MIAMI BEACH, FLORIDA	
SURFSIDE WORK CENTER	
SOUTHERN BELL TELEPHONE AND TELEGRAPH CO.	
W. KENYON DRAKE & ASSOCIATES - ARCHITECTS	
237 WEST FORBETH STREET JACKSONVILLE, FLORIDA	
DATE: MAY 1966	53
6619	
MARK: E.M.C.	
INDEX: T.E.P.

PLAN REVIEW NOTICE SURFSIDE, FL 33141

PLANS PROCESSING APPROVALS

SURFSIDE SOC WORKCENTER

OLC NO. M6213
DRAWING NO. A2001

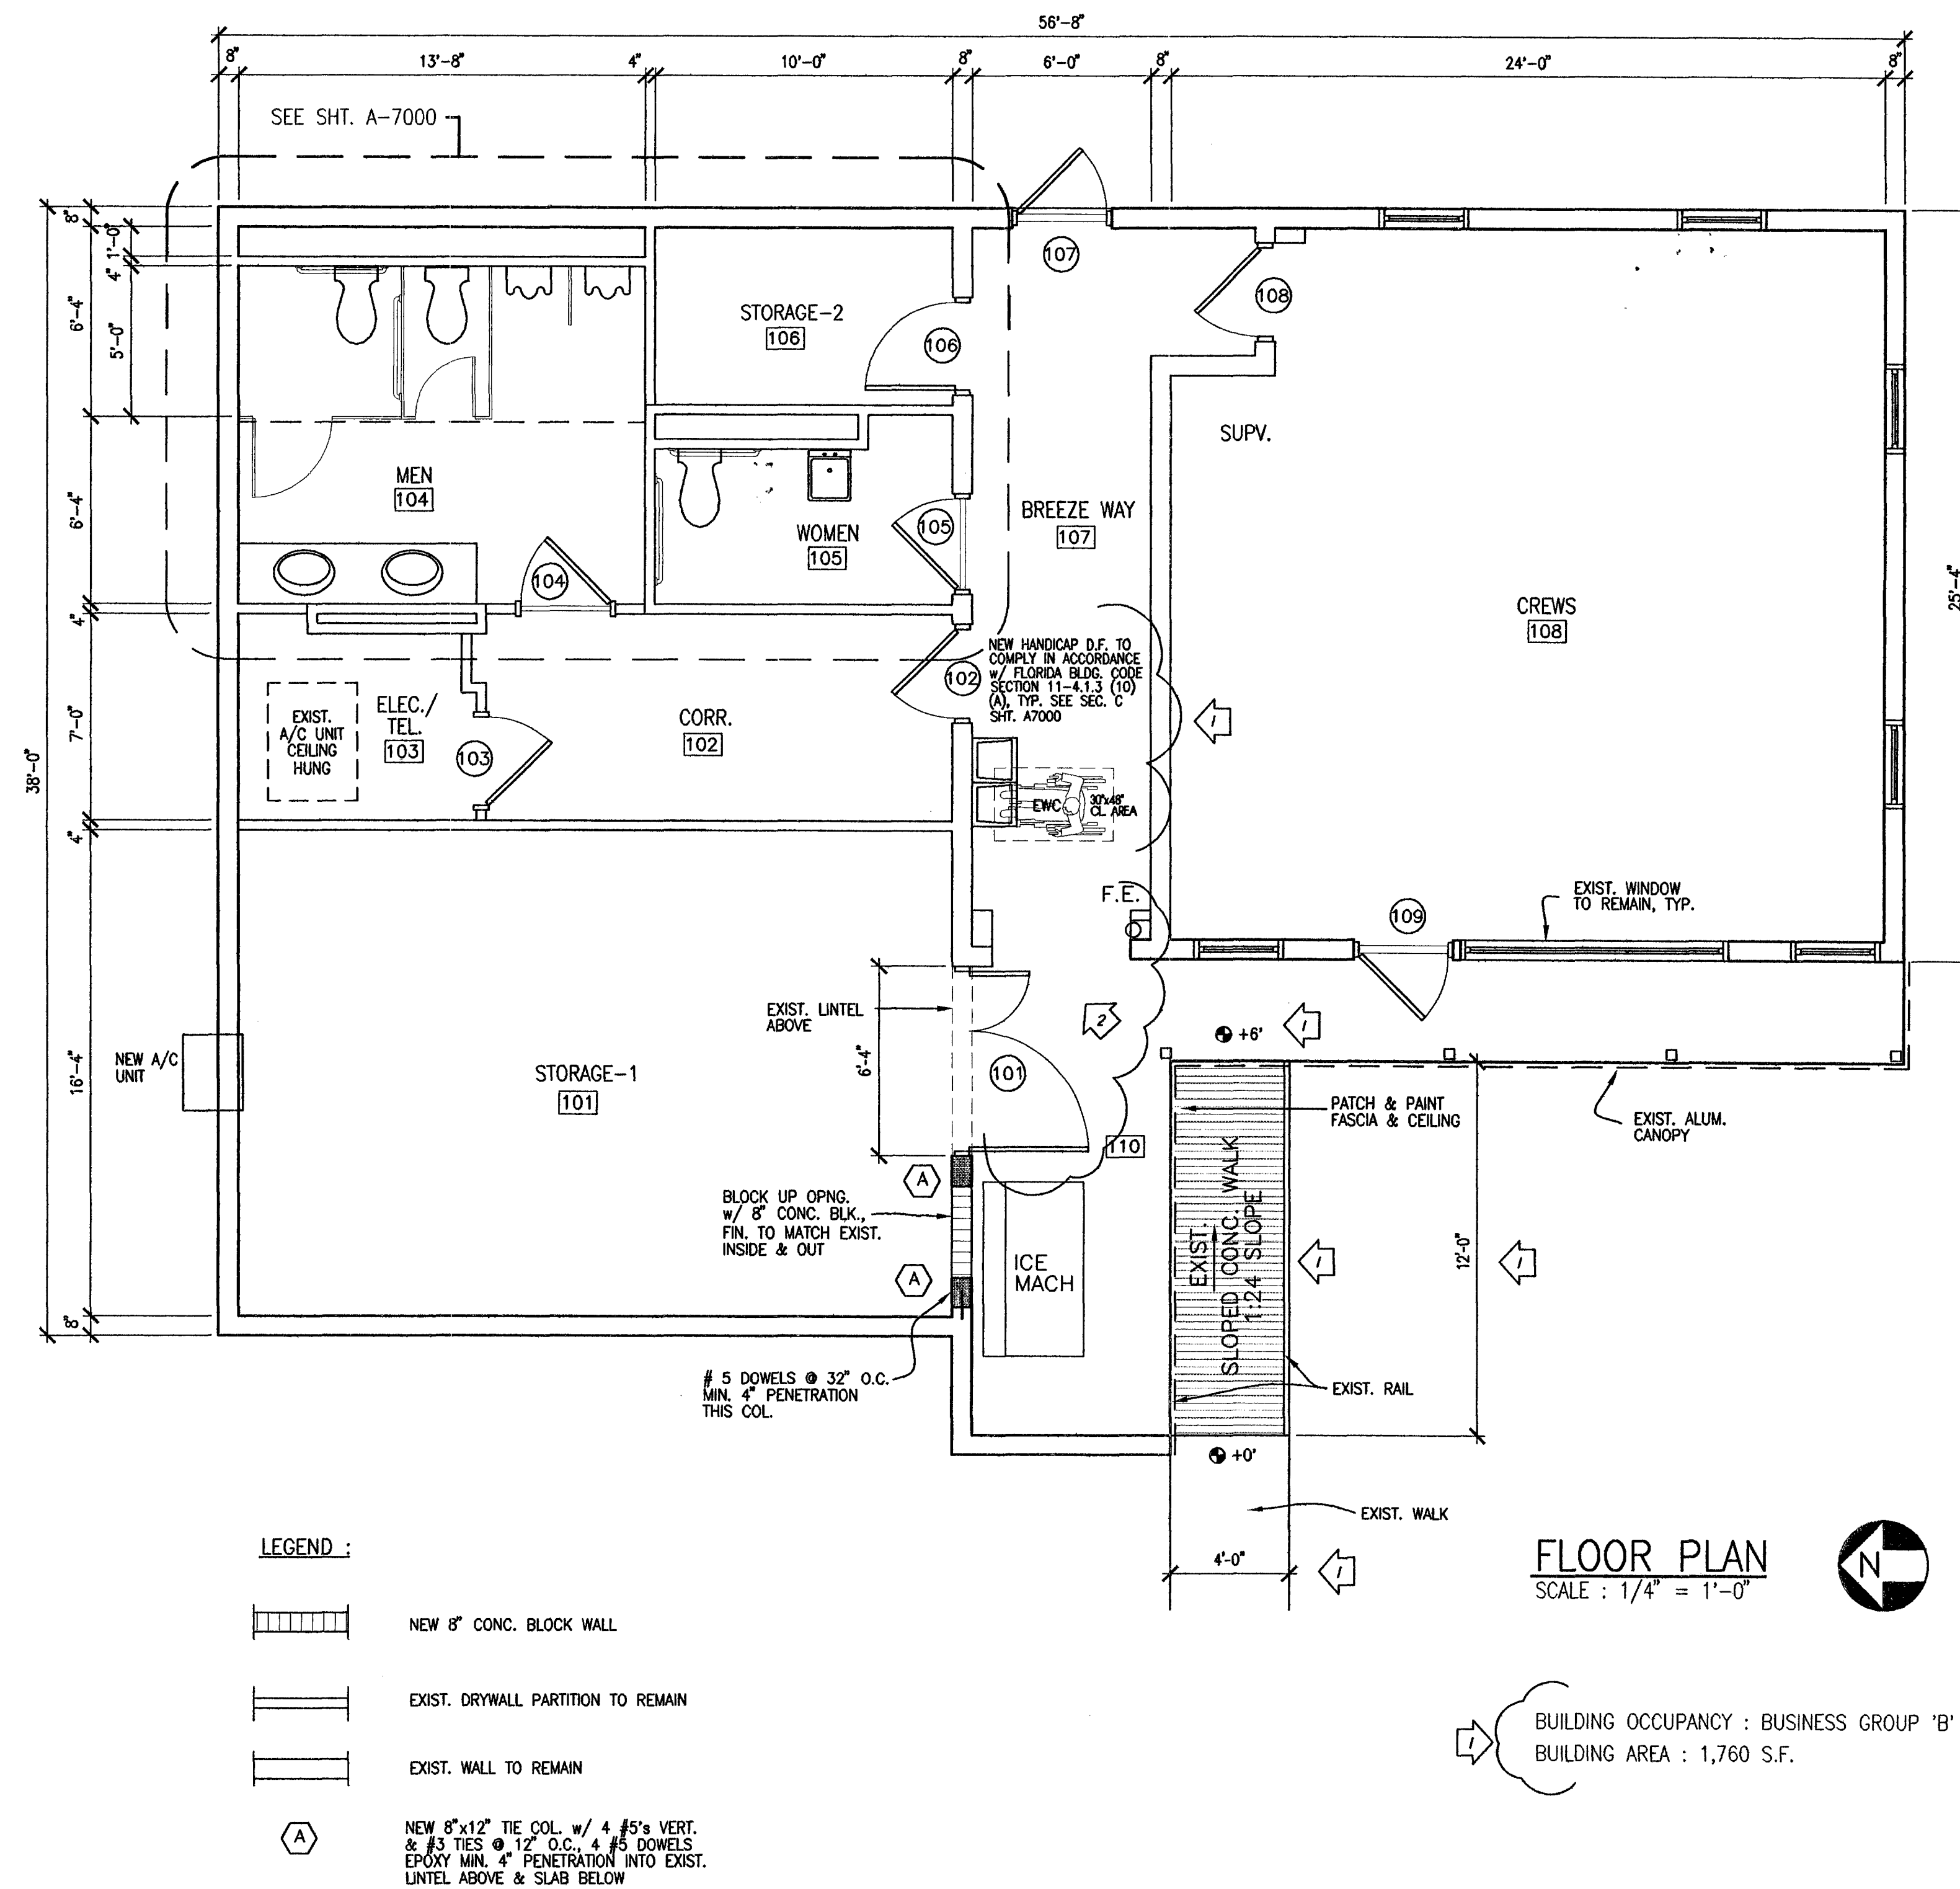
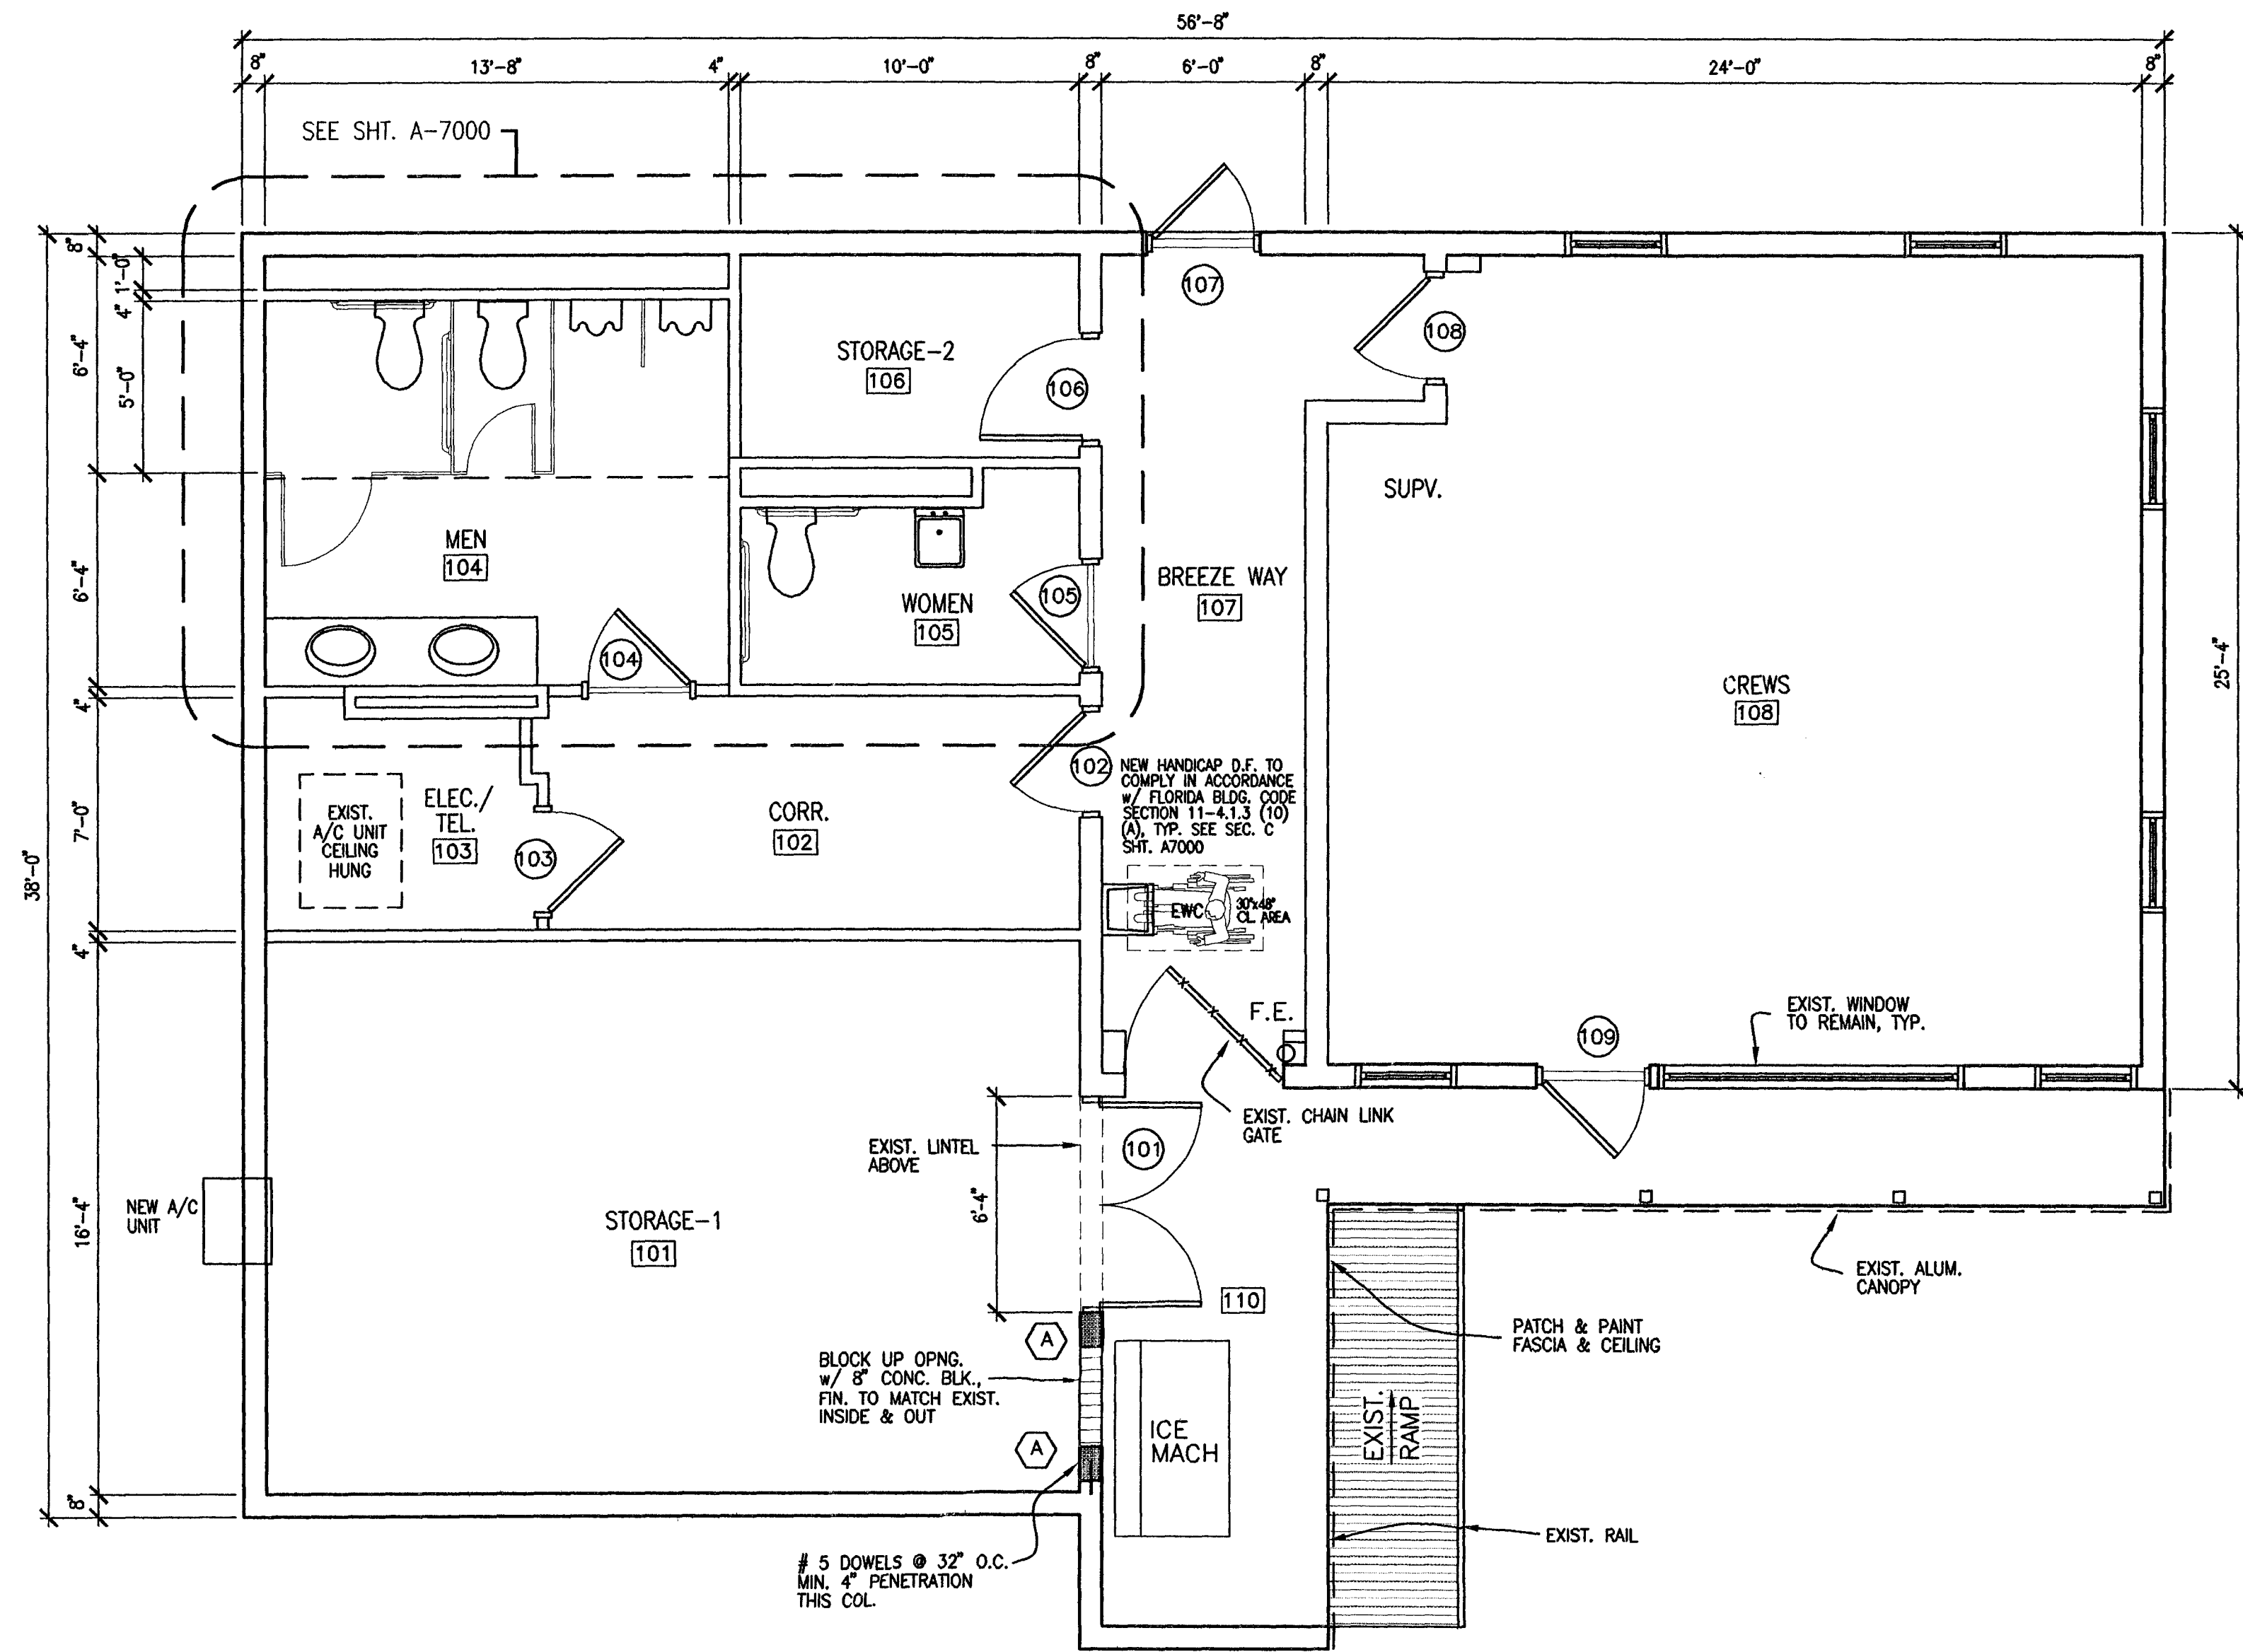
sheet a2001:

1. need to provide info on the ramp its ratio along with handrails etc per nfpa 101 chap 7
2. door conflict between the storage room and breeze way gate door
3. provide occupancy load per nfpa 101 chap 7
4. need to state on plans all codes used for this project
5. all doors need to swing in the direction of egress travel (i.e. breeze way gate door)
6. provide floor elevation for all exit doors, needs to be level on both sides with 1/2" across the threshold
7. door #109 when open needs to maintain 22" clearance along the corridor for exiting
